APPLICATION NO.	FILING DATE	FIRST NAMED INVENTOR	ATTORNEY DOCKET NO.	CONFIRMATION NO.
09/901,000	07/09/2001	Teruo Kamada	SHM/12585	6853

Office Action Summary

Applicant(s)
KAMADA, ET AL

Examiner
Bryan Fischmann

FIG. 19A
(PRIOR ART)

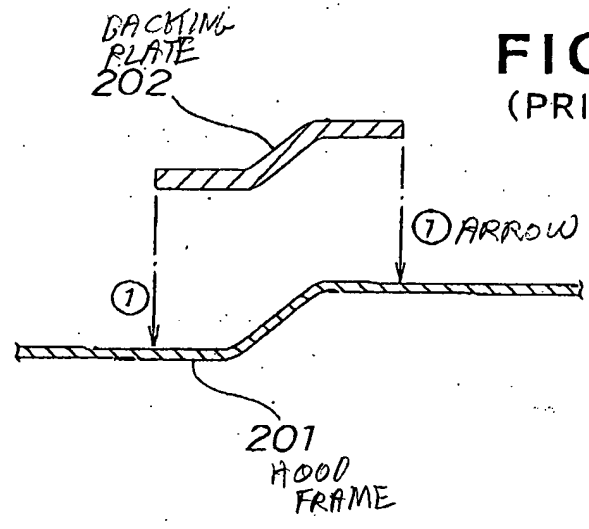
Prior art Figures 19A and 19B and associated Background portion of the Instant Application related to these Figures teaches a vehicular part comprising a blank material (201) formed from a sheet metal (line 13 of page 2 of the Instant Application) and having a bent portion (204 and 205); and

a backing plate (202) joined with the blank material (Figures 19A and 19B) and having a bent portion (204 and 205) corresponding in position to, and bent along a same bending line as, the bent portion of the blank material.

Prior art Figures 19A and 19B and associated Background portion of the Instant Application related to these Figures fails to teach the backing plate has at least one aperture formed at the bent portion and located on the bending line.

Therefore, it would have been obvious to one of ordinary skill in the art at the time the invention was made to utilize a row of holes along the bending line of the bent portion of the backing plate of Prior Art Figures 19A and 19B, as taught by British Patent 2197810.

Prior art Figures 19A and 19B and associated Background portion of the Instant Application related to these Figures teaches a vehicular part comprising a blank material (201) formed from a sheet metal (line 13 of page 2 of the Instant Application) and having a bent portion (204 and 205); and

a backing plate (202) joined with the blank material (Figures 19A and 19B) and having a bent portion (204 and 205) corresponding in position to, and bent along a same bending line as, the bent portion of the blank material.

Prior art Figures 19A and 19B and associated Background portion of the Instant Application related to these Figures fails to teach the backing plate has at least one aperture formed at the bent portion and located on the bending line.

Therefore, it would have been obvious to one of ordinary skill in the art at the time the invention was made to utilize a row of holes along the bending line of the bent portion of the backing plate of Prior Art Figures 19A and 19B, as taught by Japanese Patent 59-202119.

FIG. 19B

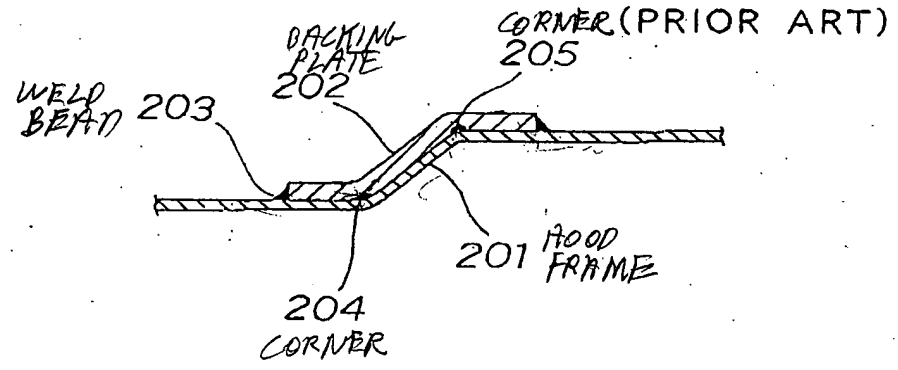
Regarding claim 9, note that Prior Art Figures 19A and 19B show a backing plate and blank material which are configured similarly to Applicant's Figures 1-3.

Regarding claim 9, note that Prior Art Figures 19A and 19B show a backing plate and blank material which are configured similarly to Applicant's Figures 1-3.
